## **Objection: DA 2021-703 for revised Ascent Apartments proposal for consolidated sites 11-15 Church St**

Visual Impact Assessment by Perception Planning, in support of DA 2021-703 for Residential Flat Building (11 storey) 11 – 15 Church St, Nelson Bay, NSW, prepared for client Coho Properties, 13/8/21

Figure 4 - Important view map (NB Town Centre and Foreshore Strategy)

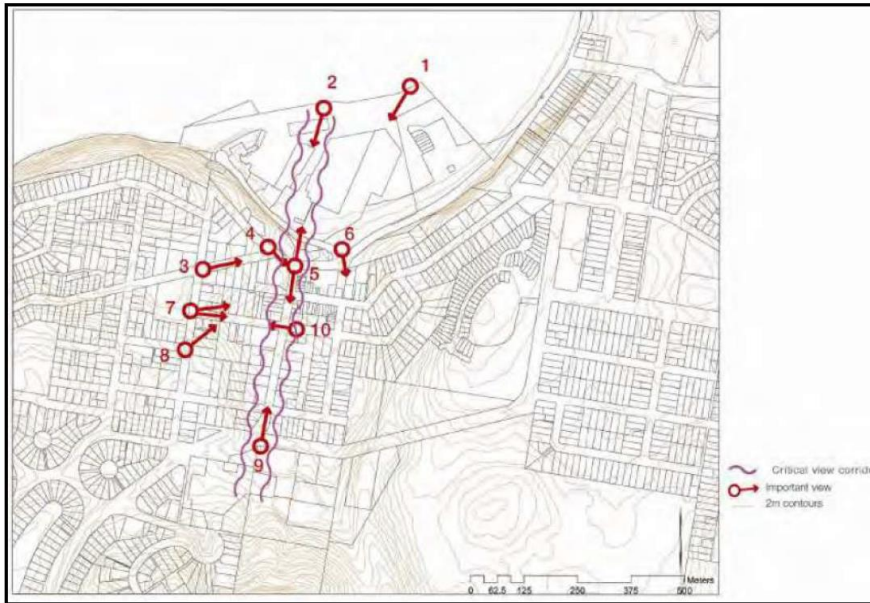
At least 3 of these ‘important views’ – 1, 2 & 8 – are directly impacted by the proposed new building at 11-15 Church St.
